L4445A-02

S E R V I C E N O T E

L4445A Microwave Switch/Attenuator Driver

Instrument cannot operate in 400 Hz

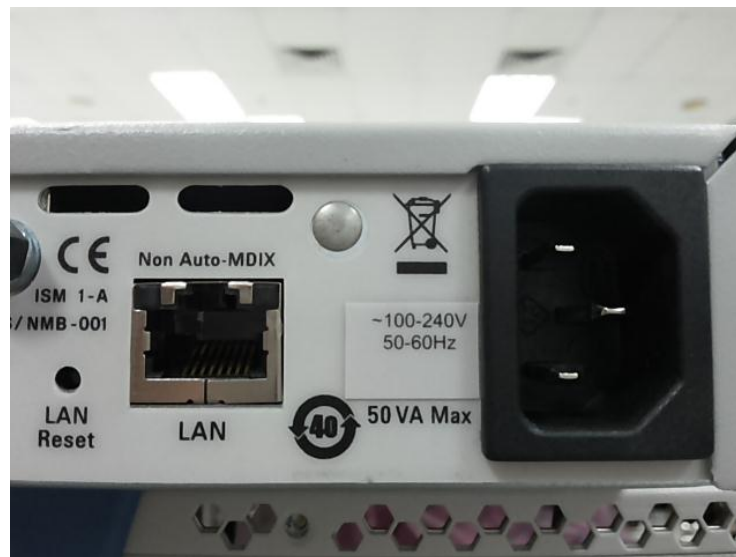
It has been found that the instruments with affected serial numbers listed above have incorrect information printed on the power rating label. The instrument does NOT support 400 Hz operation at 100-127V.

Order a L4421-84303 L44xxA Power Rating Label and apply it over the existing power rating information on the instrument. After applying the L4421-84303 label, it should look similar to the picture below.
